PRODUCT BULLETIN # 16629

Issue Date: 26-Apr-2011

TITLE: Packaging change for 7" Reels

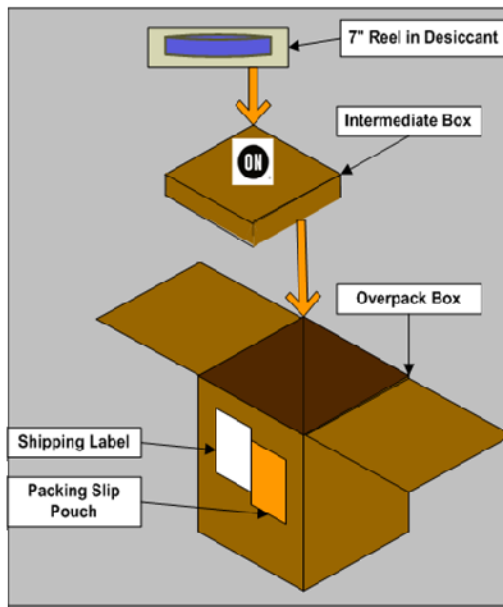
Current: 7" reels placed in desiccant bag in individual intermediate box.

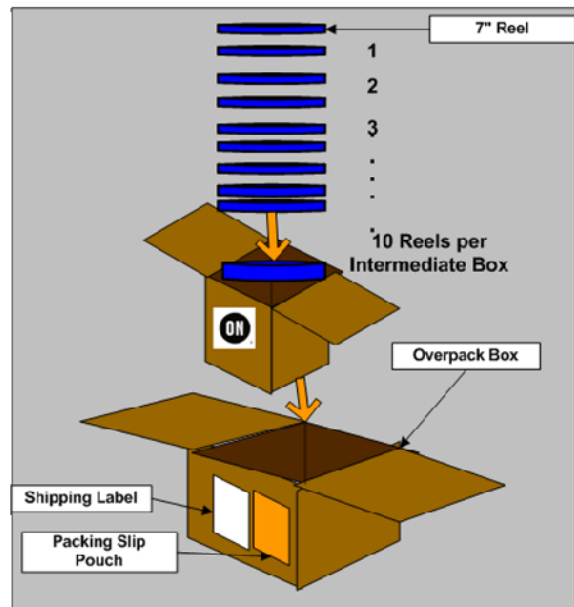
To be: 7" reels placed 10 per Intermediate box, no desiccant bag.
